| Technical Bulletin | Model 6 Cyl. | Group 6 |
| Subject Replace Cabriolet Locating Pins | Part Identifier 6110 | Number 9513 |

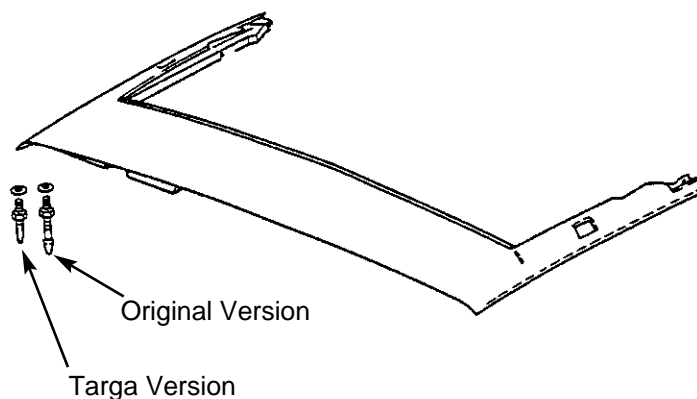
Concern: When the Cabriolet top is opened, the locating pins may stick or bind in the windshield frame guides.

General Information: If the Cabriolet top locating pins stick or bind in the windshield frame guides, the Cabriolet top locating pins should be changed to the Targa soft top version (shorter) and the top should be re-adjusted accordingly.

Parts Information: Locating Pin (Targa)
911 565 074 40 (Qty. 2)
